LiDAR Quality Assessment Report

Materials Received: 2/14/2012	Project Type: ARRA Partnership
Project ID: G10AC00103	Project Description: ARRA-WA_PierceCounty_2011
Project Alias(es):	Year of Collection: 10/2010 - 09/2011

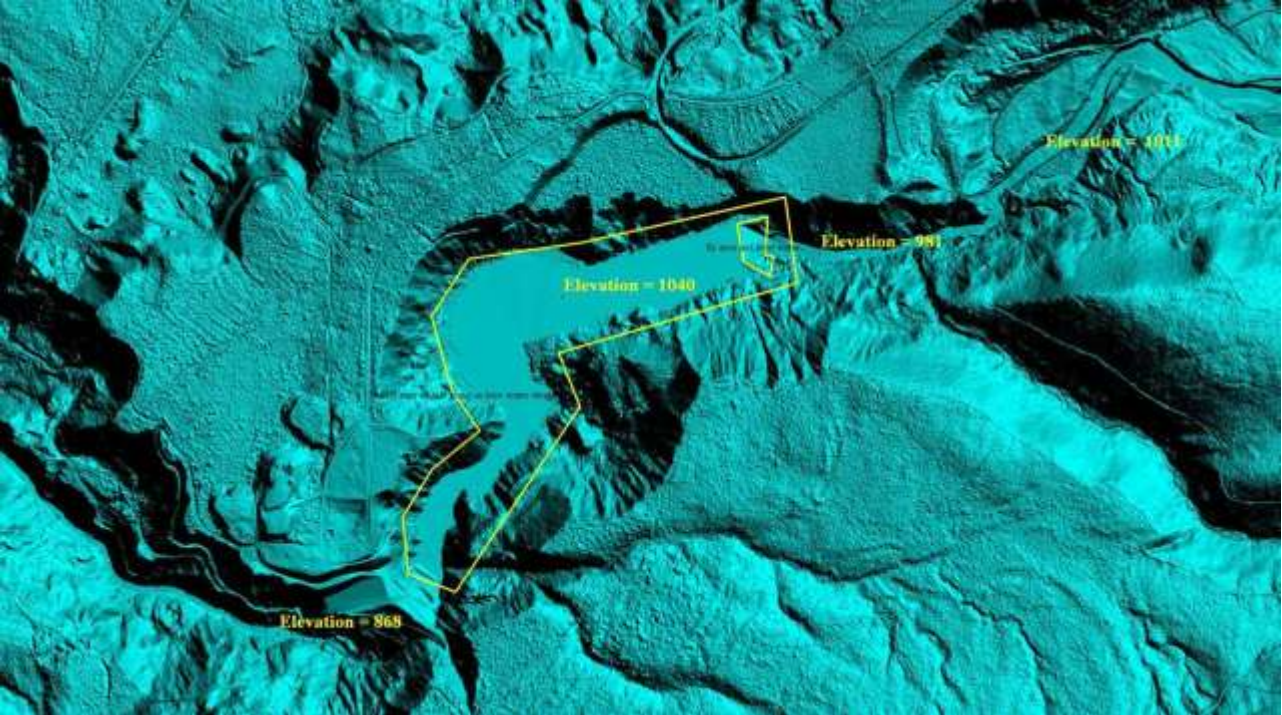
Land Cover Category	# of Points	<u>Fundamental Vertical Accuracy @95% Confidence Interval (Accuracy_z)</u> Required FVA = 24.5 or less.	<u>Supplemental Vertical Accuracy @95th Percentile Error</u> Target SVA = 36.3 or less.	<u>Consolidated Vertical Accuracy @95th Percentile Error</u> Required CVA = 36.3 or less.
Open Terrain	11,166	0.190		
Tall grass	162		0.743	
Shrubs	307		0.911	
Trees	281		0.533	
Short grass	397		0.291	
Consolidated	12,313			0.222

Image?

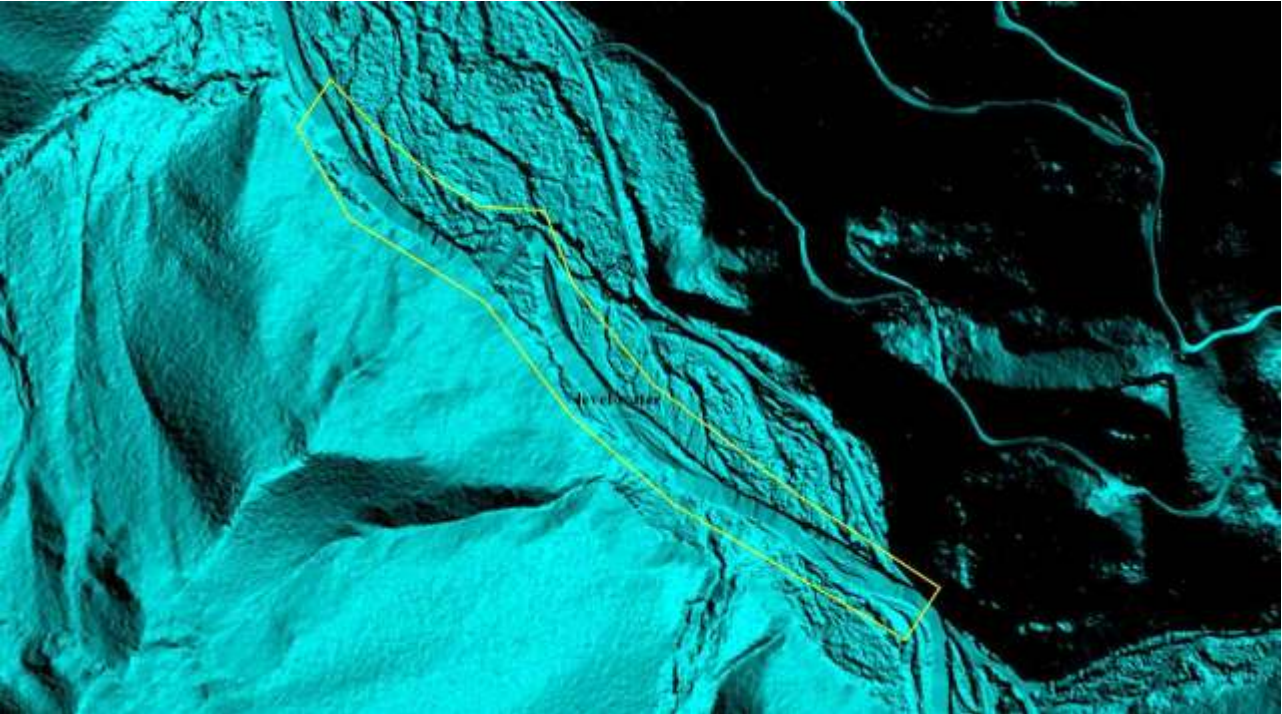
River elevations are different due to flying times, one flown in 2010 and one flown in 2011. Not fixed but reported here.
